RE: Responses to Technical Review 1
White Barn Brown Bear Car Wash
8907 & 8915 Soper Hill Rd
City File No. PA23-021
Our Job No. 22681

Letter from City of Marysville dated December 5, 2023

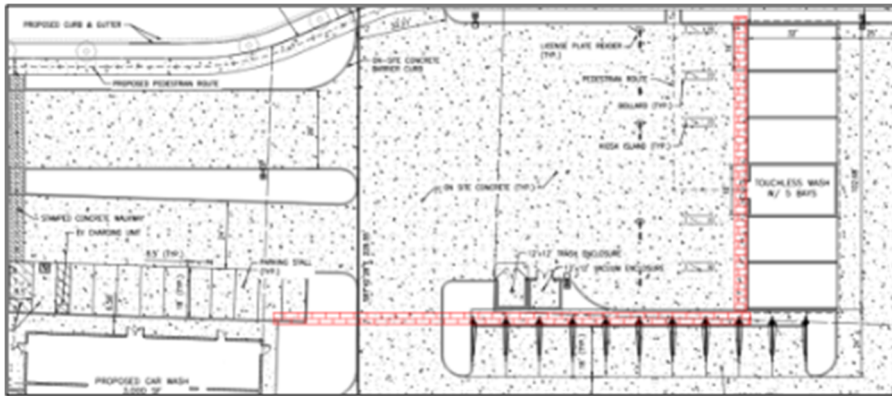
3. *There should be a pedestrian connection from the Main Car Wash Building to the island south of the vacuum station. As a method to satisfy the above comment 2.2 as well as this pedestrian connectivity issue, staff suggests the following revision:*

Response: Refer to sheet C1.0, the pedestrian route from Drive A to the touchless car wash bays has been revised to stamped concrete.
